MFN 06-298  
Supplement 1

**Subject: Response to Portion of NRC Request for Additional Information  
Letter No. 38 Related to ESBWR Design Certification Application –  
Structural Analysis - RAI Numbers 3.8-1 S01, 3.8-2 S01, 3.8-4 S01,  
3.8-5 S01, 3.8-7 S01, 3.8-9 S01, 3.8-10 S01, 3.8-12 S01, 3.8-15 S01, 3.8-  
29 S01, 3.8-30 S01, 3.8-31 S01, 3.8-42 S01, 3.8-52 S01, 3.8-53 S01, 3.8-  
54 S01, 3.8-58 S01, 3.8-60 S01, 3.8-61 S01, 3.8-67 S01, 3.8-70 S01, 3.8-  
71 S01, 3.8-72 S01, 3.8-74 S01 & 3.8-98 S01 - Supplement 1**

# **ENCLOSURE 1**

## **MFN 06-298, SUPPLEMENT 1**

**Figure 3.8-4 (1) Comparison in M-N interaction between ACI 349-01 and ASME 2004-Section III, Division 2**

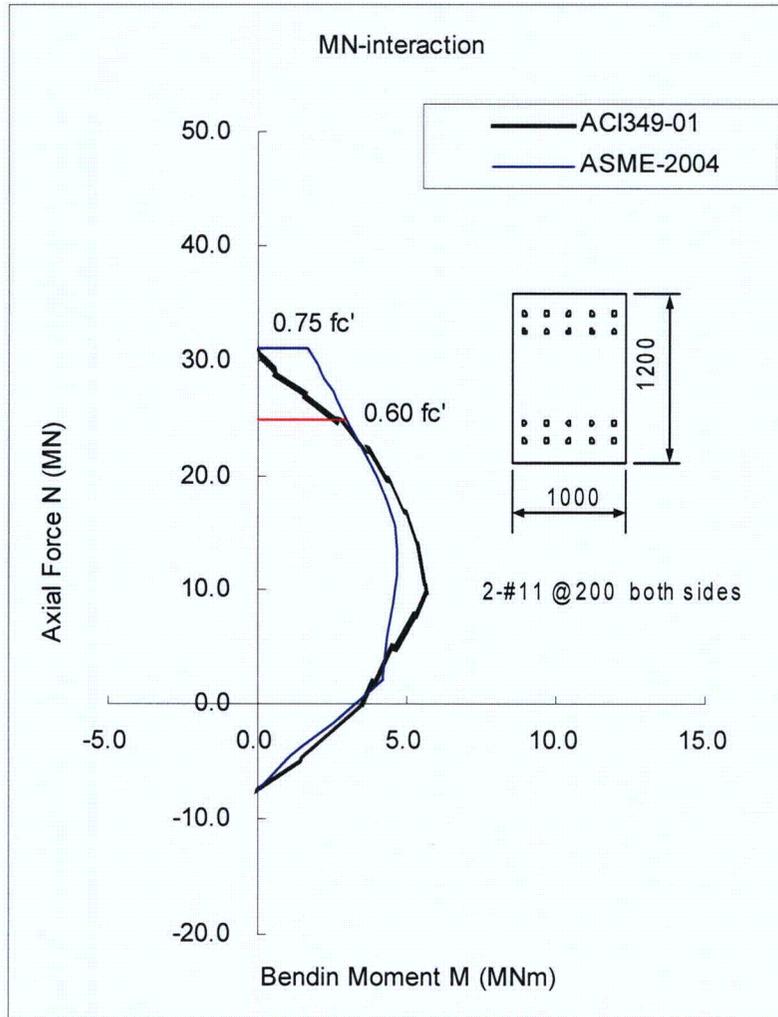
*During the audit, GE explained that the loads and load combinations for the entire RB from the ACI 349 and ASME Section III, Division 2 are checked against the acceptance criteria in ASME Section III, Division 2 Code. GE indicated that they have confirmed that the acceptance criteria in the ASME, Section III, Division 2 Code are more conservative than the acceptance criteria in ACI 349. GE was requested to provide the technical basis for this conclusion. Therefore, in effect the entire RB is designed to both the ASME Section III, Division 2, Subsection CC and the ACI 349 Code. In this case, the current boundary shown in DCD Figure 3.8-1 for the ASME jurisdictional boundary for all aspects of design, construction, fabrication, and inspection is acceptable. GE will provide a supplemental response to this RAI and RAIs 3.8-67, 101, 102 and 103 to reflect the above.*

Figure 3.8-4 (1) shows the comparison of M-N (bending moment-axial force) interactions that define the relationships between allowable bending moments and axial forces calculated in accordance with ACI 349-01 and ASME 2004 Section III, Division 2 codes (for factored primary and secondary loads).

As shown in Figure 3.8-4 (1), the ASME allowable values are smaller, except in the high axial force (compression) region in which the ASME limit is  $0.75f'_c$  for primary plus secondary membrane and  $0.60f'_c$  for primary membrane. For additional conservatism,

the  $0.60f'_c$  limit, which is lower than the ACI 349-01 allowable, is applied to the ESBWR design. Therefore, the use of the ASME acceptance criteria is a conservative design approach for the design of ESBWR concrete structures that are integrated with the containment.

Figure 3.8-15(1) Envelopes of Transient Pressure Curves at DBA

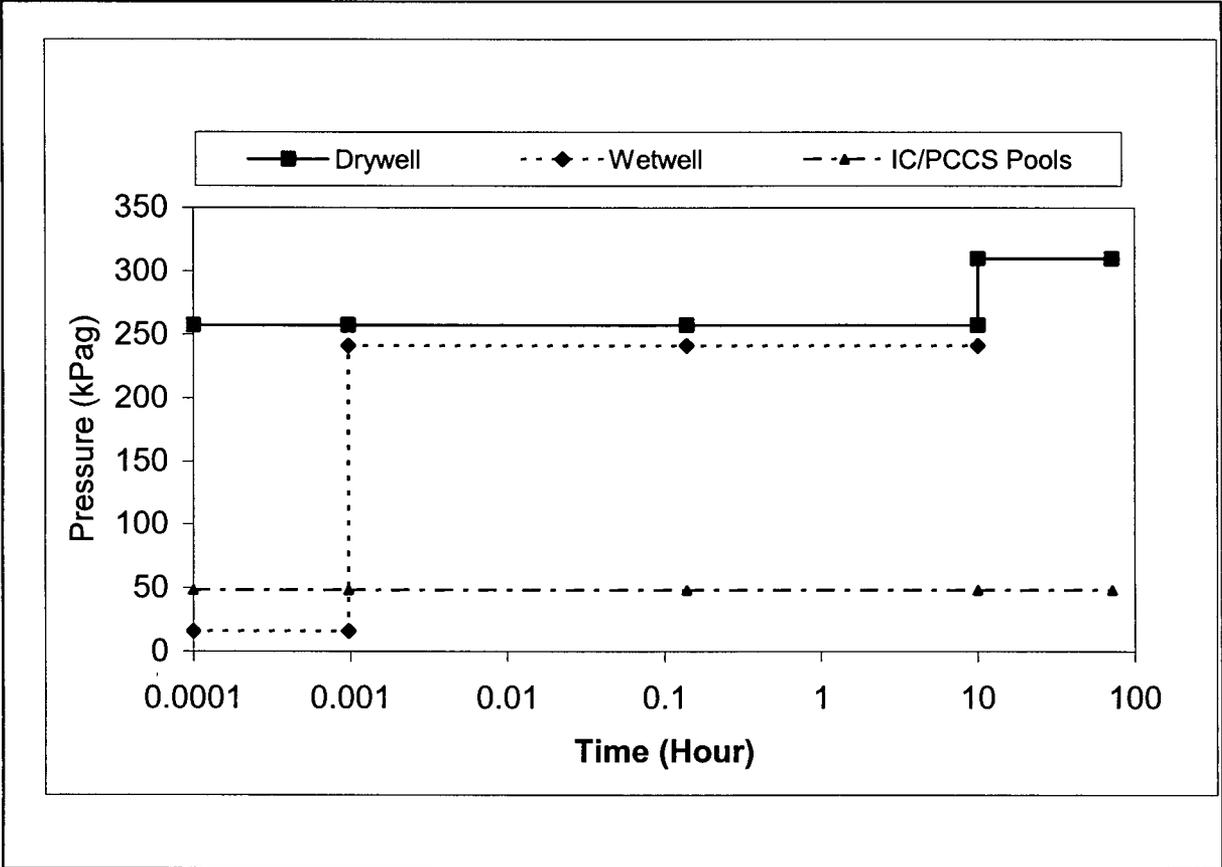
*In Fig. 3.8-15(1), should the curve for WW stop or continue until 100 Hrs? Explanation should be included how the determination was made that the axisymmetric loads are more severe than the nonaxisymmetric loads, and that the nonaxisymmetric loads did not need to be considered. Where in the DCD is the requirement for the COL Action item to confirm, in the detailed design phase, that the DLF of 2.0 is adequate to account for variation in loading function frequencies and dynamic amplification?*

Figures 3.8-15(1), 3.8-15(2) and 3.8-15(3) show the transient pressure envelopes at DBA, the areas subject to differential pressure between the Reactor Building and Containment, and areas subject to differential pressure between Drywell and Wetwell. Table 3.8-15(1) shows the load combination for design pressure loads. This table shows four load phases considered critical cases for design. Two of these two cases (e.g., 6 min. and 72 hours after LOCA) are presented in the DCD. The DLF is not considered for the pressure loads.

Figure 3.8-31 (1) Analysis Model for Support Bracket Attached Part of Drywell Head

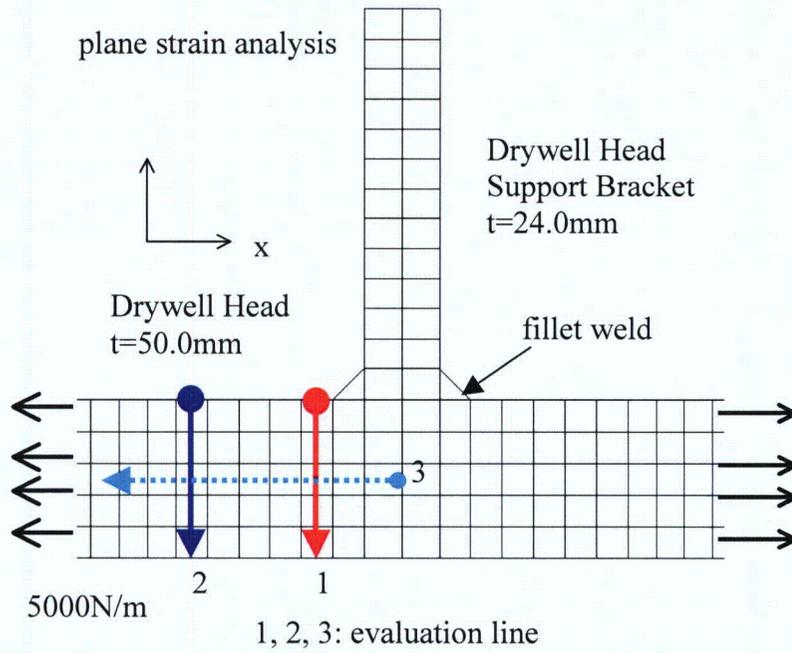
*Figure 3G.1-51, Detail C, shows six (6) drywell head support brackets. Please explain their function. How were the brackets modeled in the Service Level A and B pressure and thermal analyses of the drywell head? Were local discontinuity stresses and peak stresses calculated and considered in the Code evaluation? If yes, describe the results. If not, explain why not. Include this information in DCD Section 3.8.2 and/or Appendix 3G.*

The support brackets will be attached to the inner surface of the cylindrical portion of the drywell head by fillet welding. The simple analysis model shown in Figure 3.8-31 (1) is developed to confirm the effect due to pressure load. To simulate pressure load, both ends of the model of the cylindrical portion of the drywell head are pulled, and the stress distribution change is evaluated.

Figure 3.8-60(1) Main Steam Tunnel Overview

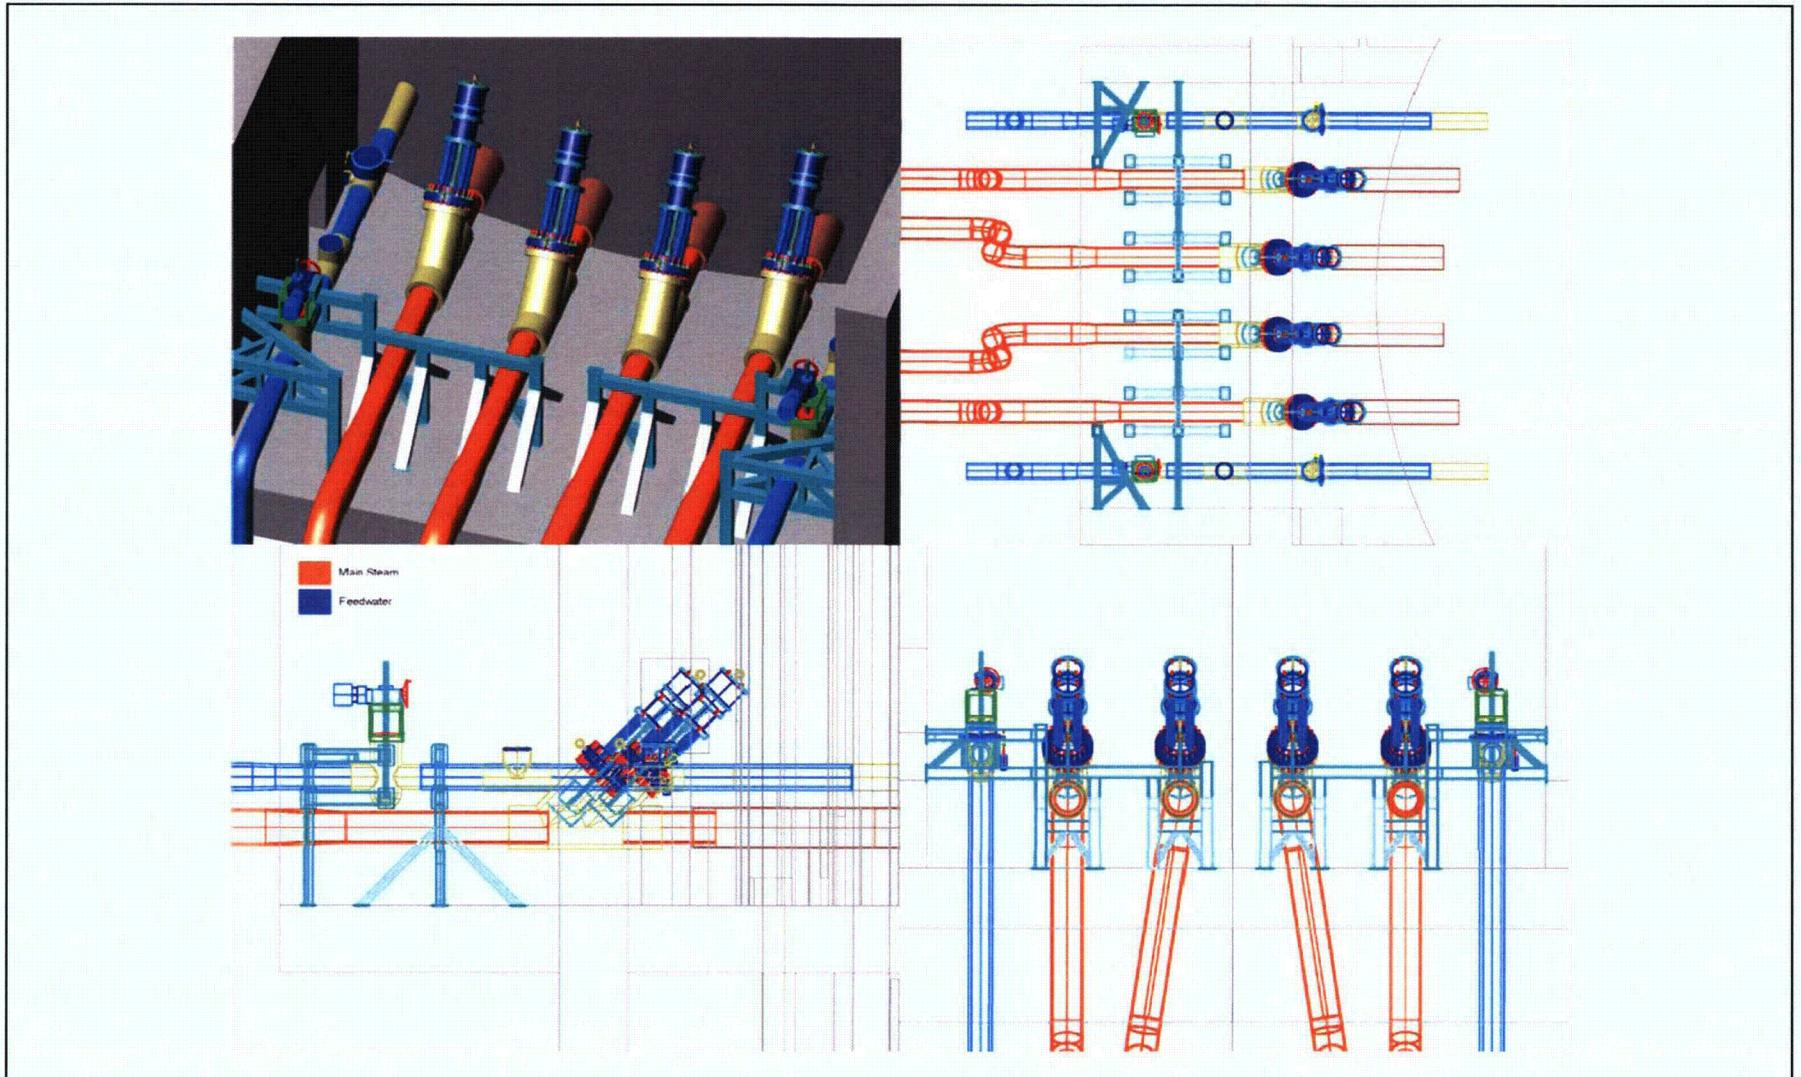
*GE needs to explain what information Figure 3.8-60(1) is trying to convey. Also the DCD revision states: "Thus the RB walls of the main steam tunnel are designed to accommodate the pipe support forces and the environmental conditions during and after the postulated high-energy." GE needs to clarify the "environmental conditions" that the tunnels are being designed to. Are they saying that "the break exclusion stress and fatigue limits as per BTP EMEB 3-1 of SRP 3.6.2" eliminate postulated breaks in the tunnel area, but the tunnel still experiences environmental conditions due to pressure and temperature from pipe breaks outside the area? GE needs to explain the source of these environmental effects.*

Figure 3.8-60 (1) is for information purposes only to show that no guard pipes are used in the Main Steam Tunnel.
